**IGEM/UP/10 Edition 4  
COMMUNICATION 1774  
2014**

The following Amendments (March 2016) apply to all copies of IGEM/UP/10 Edition 4 published in 2014.

**IGEM/UP/10 Edition 4  
COMMUNICATION 1774  
2014  
AND COMMUNICATION 1786  
2016**

The following Amendments (February 2017) apply to all copies of IGEM/UP/10 Edition 4 published in 2014 and 2016.

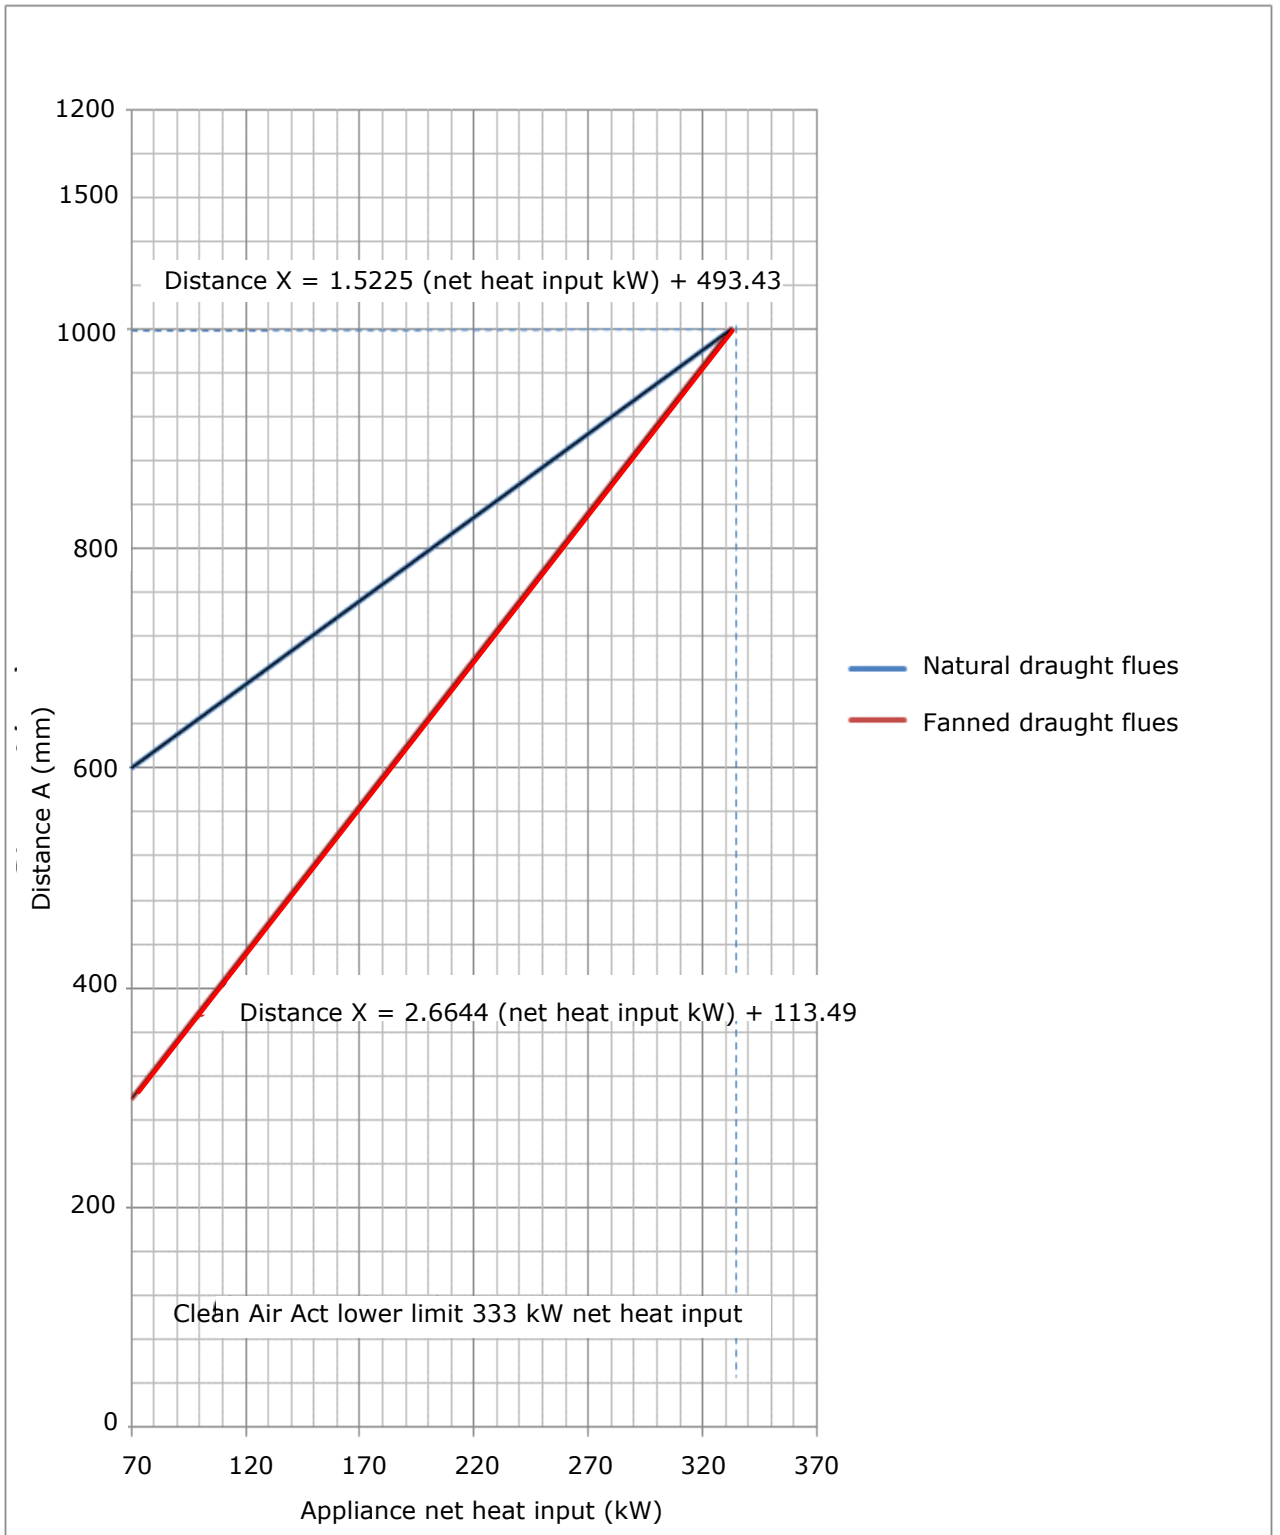
**Figure 8 Delete the Figure. Substitute:**

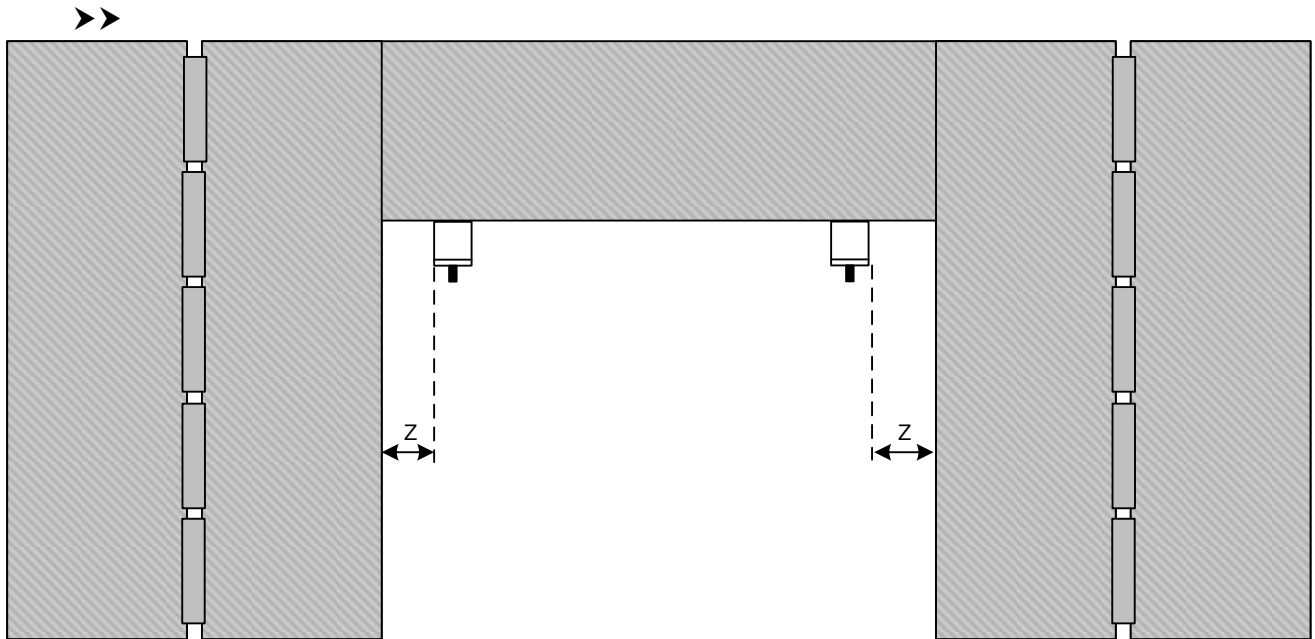
**Figure 11B Delete the Figure. Substitute:**

Z is equal to line Y on Figure 7, see clause 8.7.3.10.

*Note: The length of the vertical walls must not allow products of combustion to build up and/or be likely to cause a nuisance under unfavourable atmospheric conditions, due to poor cross flow of air. ◀◀*

**AN EXAMPLE OF A FLUE/CHIMNEY IDENTIFICATION PLATE <<**

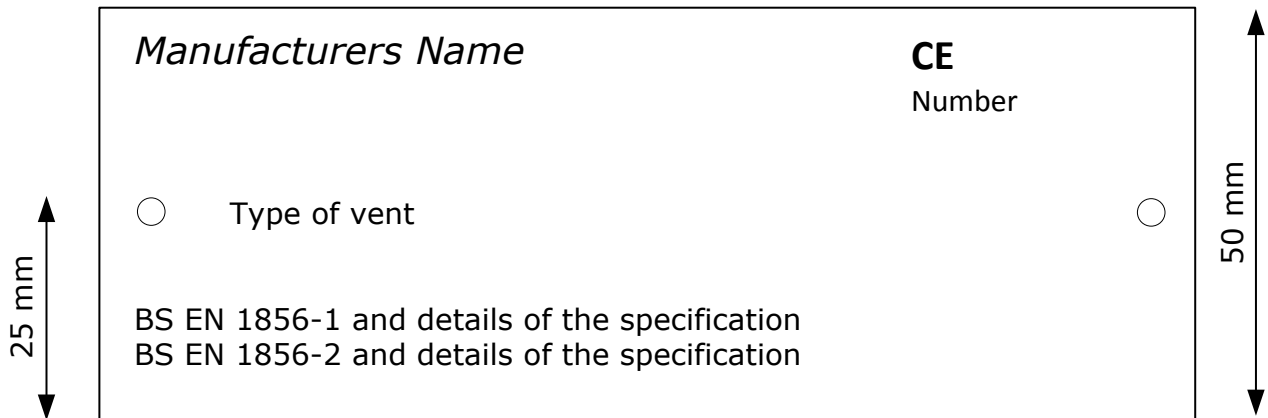
**Appendix Add:  
12**

In accordance with BS EN 1856-1 chimney identification plates retaining information related to the product specification and are to be permanently secured to a chimney system and/or in close proximity to it in an un-obstructive but visible location. Suitable fixing positions would be either to/or near any clean outdoors, draught stabilisers, manual dampers or boiler connection components. The plate is not to be removed or defaced and in the event the manufacturer/supplier is to be informed so that the appropriate information can be restored to the chimney system.
